EDR	SW
ENGR	SW
CHKD	KAK
DWN	SW
DATE	07-30-07
REV	A

WEIGHT	COST CENTER	CONTRACT NO	PART NUMBER	NO REQD	NEXT ASSEMBLY	
DRAWN BY	Steve Willming 7/27/2007	TOLERANCES		PHPK TECHNOLOGIES 2111 BUILDERS PLACE COLUMBUS, OH 43204 614-486-4750 WWW.PHPK.COM		
CHECKED	SW 7/28/2007	FRACTION	± 1/8	FNAL DES PRESSURE VESSEL GENERAL ARRANGEMENT		
ENGINEER	SW 7/28/2007	2 PL .XX	± .01			
REVIEWED	KAK 7/28/2007	3 PL .XXX	± .005			
RELEASE DATE	07-27-07	ANGULAR	± 1/2"	SIZE	DRAWING NUMBER	
DIMENSIONS ARE IN INCHES AND PROVIDED PRIOR TO SURFACE TREATMENTS, UNLESS NOTED.		EDR NO		B	07-1963-0500	CHG A
SCALE:			SHEET 1 OF 2

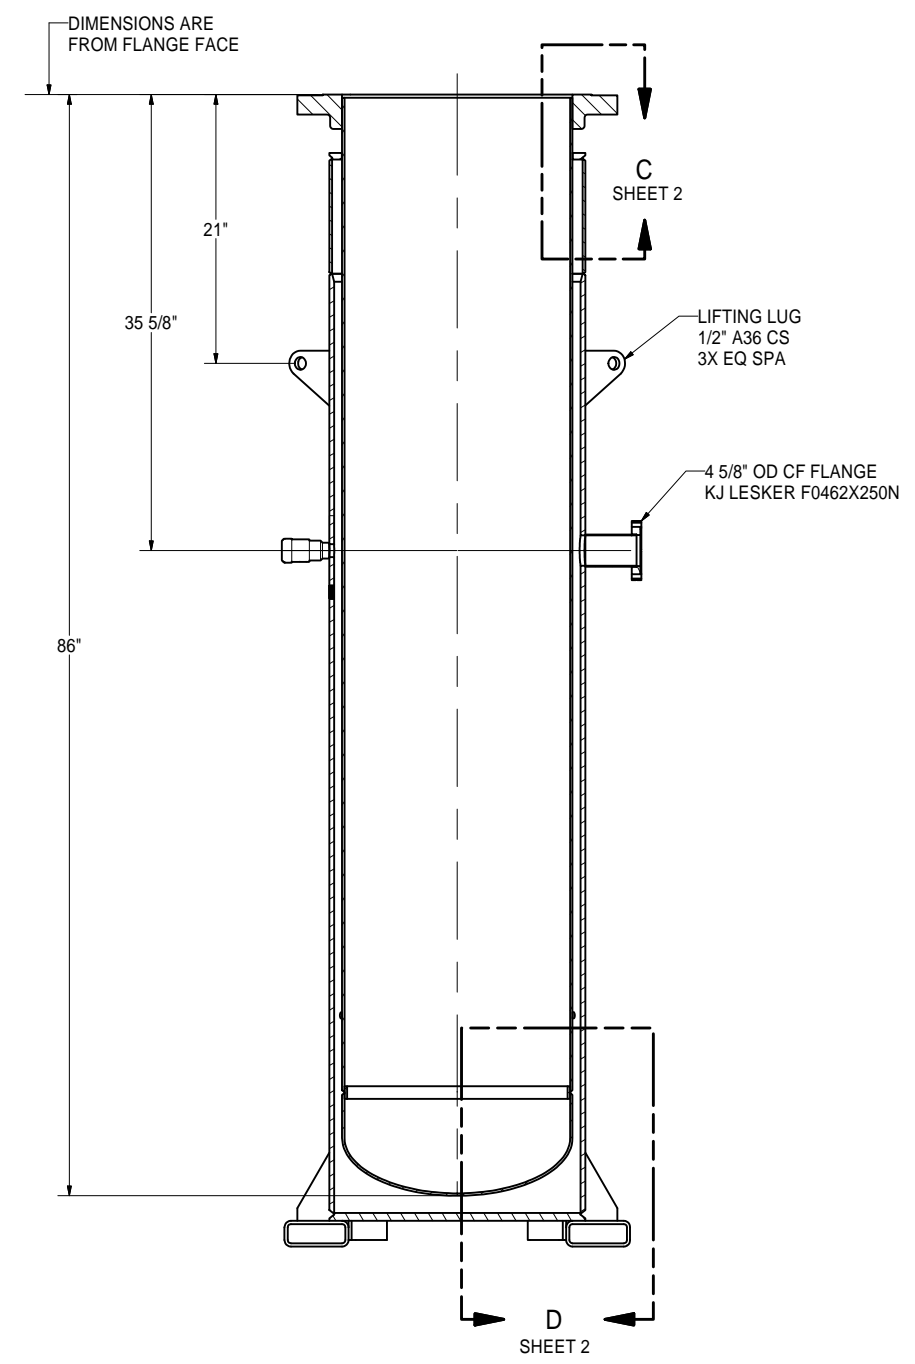
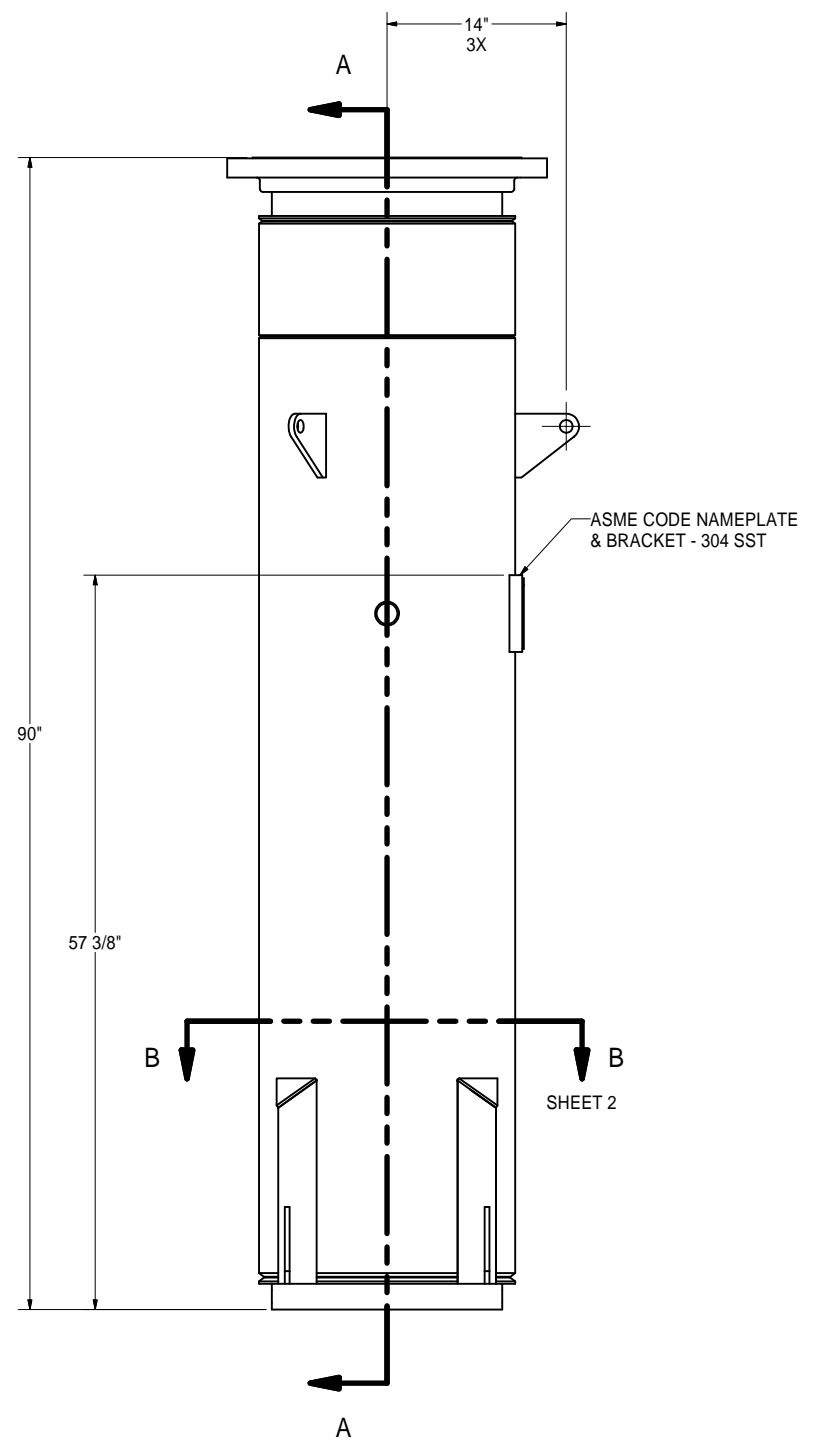
DESCRIPTION
1) REDUCED OVERALL HEIGHT TO 90" BY SHORTENING LEGS 2) ADDED MOUNTING HOLES TO FORK TRUCK STAVES
